**ADDENDUM #1**

**Bid No.: 50-97299** **Bid Opening Date: 05/25/2010**

For: LABOR, MATERIALS AND EQUIPMENT NECESSARY TO INSTALL SODIUM HYPOCHLORITE GENERATION EQUIPMENT AT THE BRIDGE CITY WASTEWATER TREATMENT PLANT - SCIP PROJECT C11

| SCALE: | CLORTEC JOB No. | SIZE: | REV: |
|---|---|---|---|
| DWG No: CP00060-ML-00 | | SHEET: 2 OF 2 | |

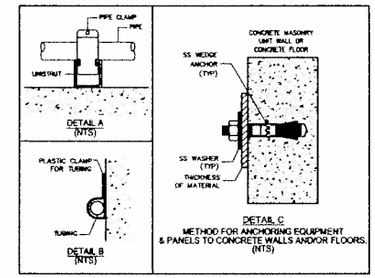
4) RE Notes Dwg ML – 00 Sht 2 –
   a. Q. Is ventilation in the existing building required? Dwg. note states that ventilation is sized by others.
      A. The existing ventilation is sufficient. No additional ventilation is required.

b. Q. Are existing floor drains adequate for the new equipment? Dwg. note states floor drain required for equipment.
      A. The additional floor drains are sufficient. No additional floor drains are required.
